TRANSPORTATION IMPACT ASSESSMENT FOR The Willows at Ashcombe Mansion

**March 24, 2020
Revised September 28, 2020**

September 28, 2020 – Revised per PennDOT review comments received September 25, 2020. Text changes regarding tree trimming.

Response Comments**Date:** 09/25/2020**Application Number:** 215708, Cycle No.2**Form Letter Notes**

STUDY AREA - FIGURE 1

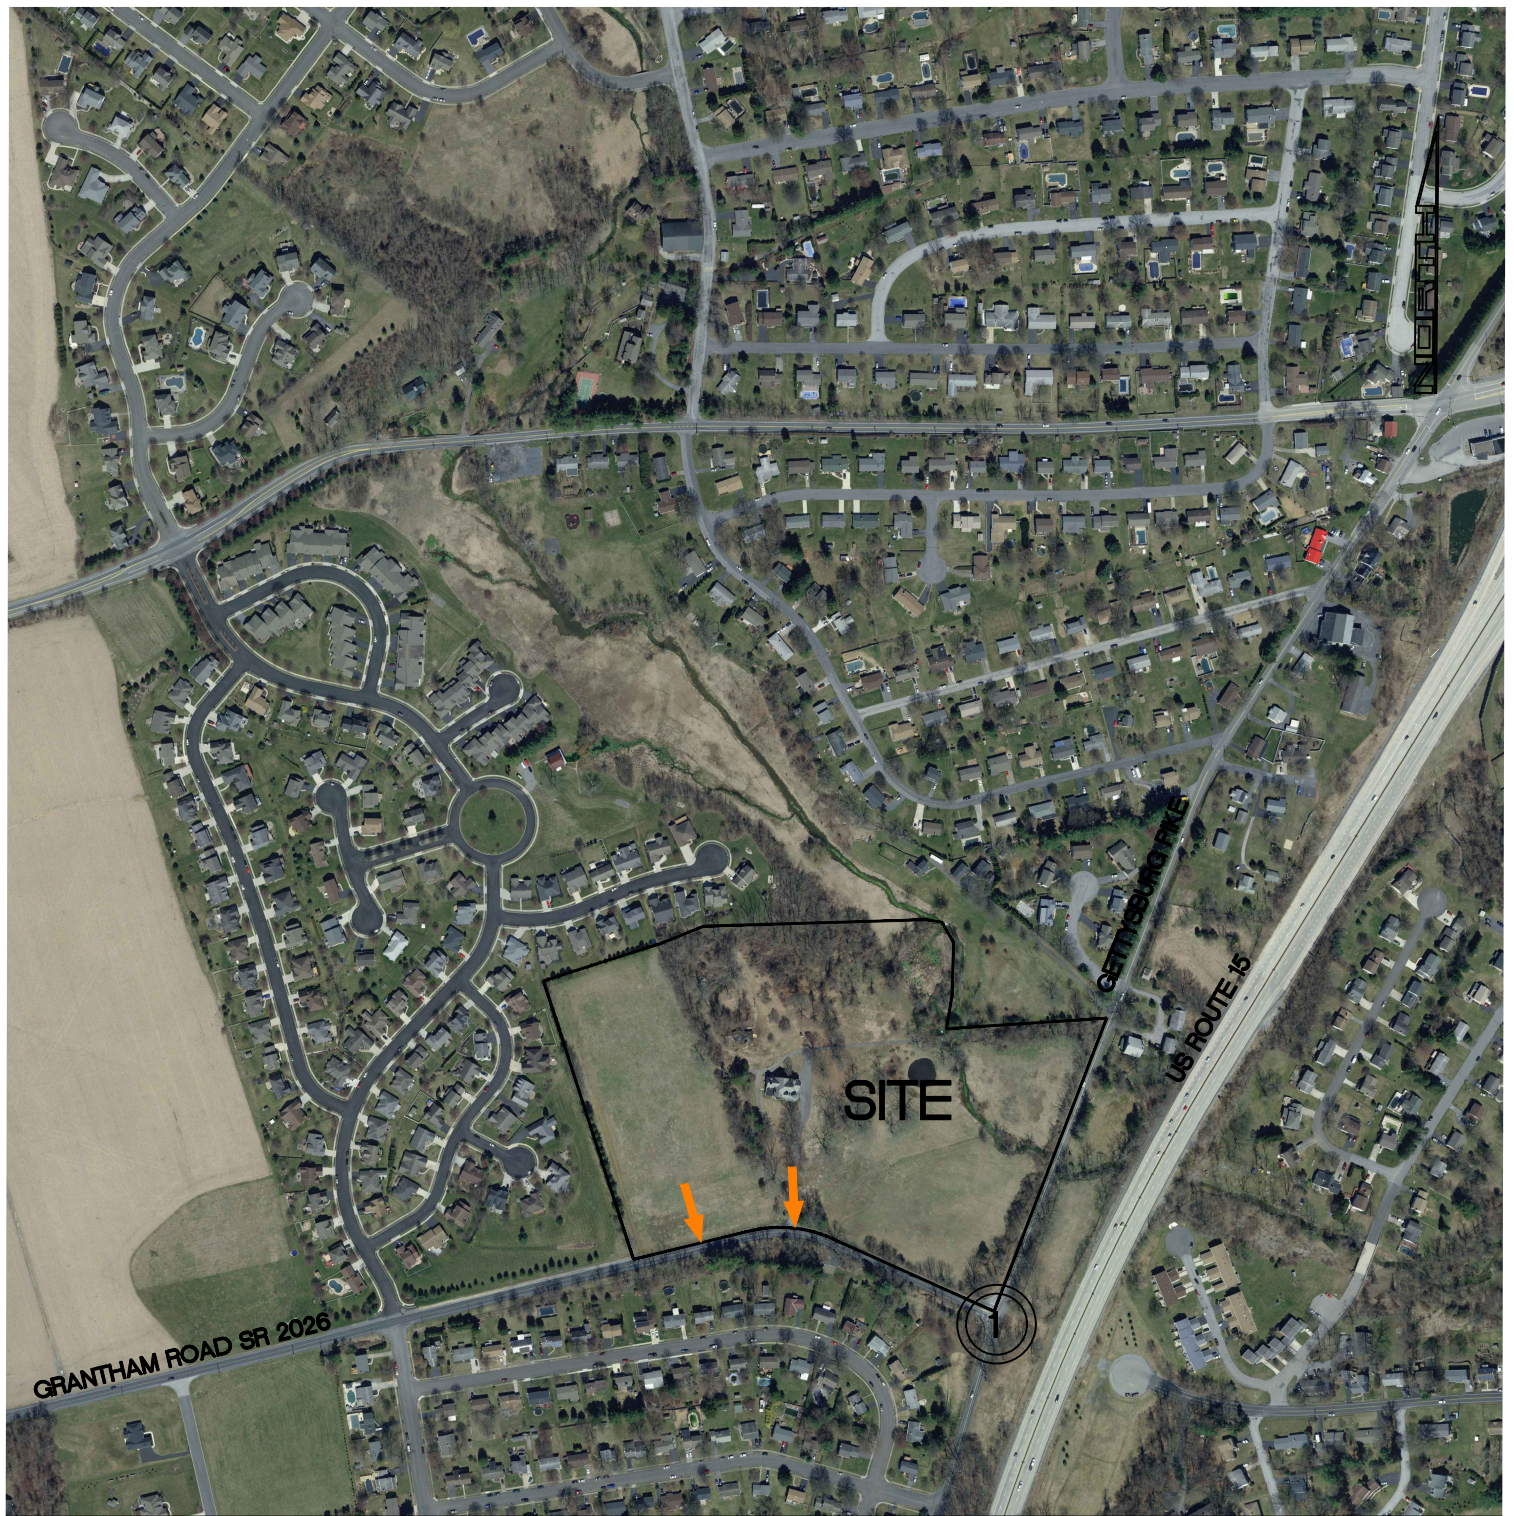
10. *Review and clarify the growth rates statement in the Introduction, Scope on page 6, and review road names and labels in Figure 1 on page 7. The SR # for Grantham Road is inconsistent.* **The introduction section has been reviewed and clarified. Figure 1 has been revised.**

FIGURE 5C SHEET 1 OF 1

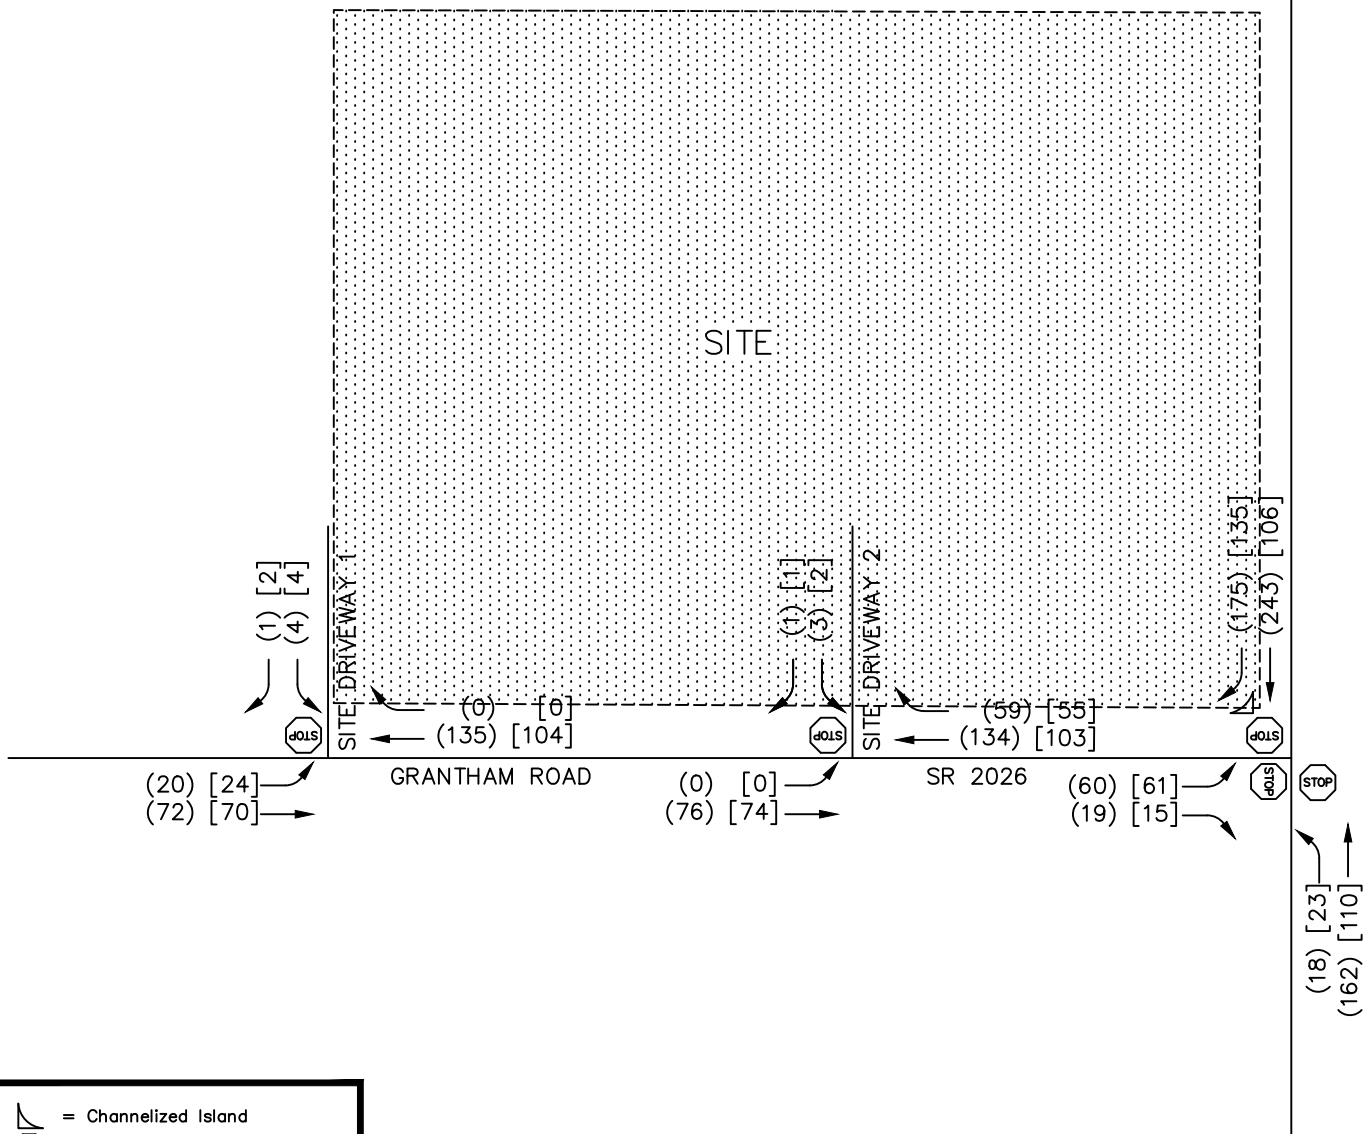
5. *The Applicant must verify the volumes were accurately input into the turn lane warrant analysis worksheets. **Turn lane warrant worksheets have been verified and match the volumes on Figure 5C. Heavy vehicle percentages have been updated as noted in the response to comment 6.***
